Change Request form

Description of requested change:

TIPS URD v1.0.0 - §.5.4.4 – New requirements

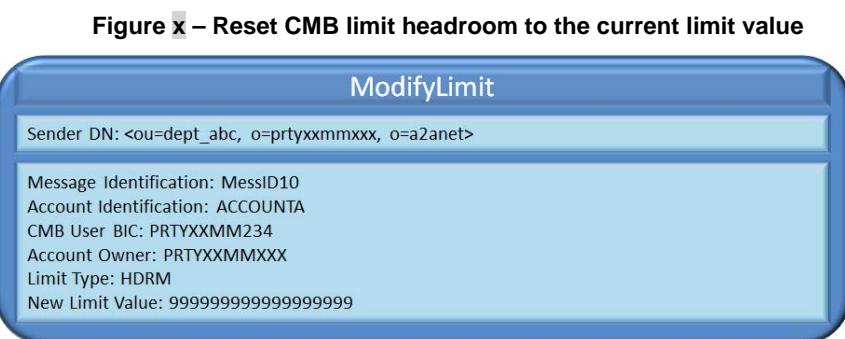
Limit management can be performed in U2A as well as A2A mode, the latter involving messages *ModifyLimit* and *Receipt*.

Examples involving limit management are listed in sections 2.9.1.1.7, and 2.9.1.1.8, 2.9.1.1.9, 2.9.1.1.10 and 2.9.1.1.11.
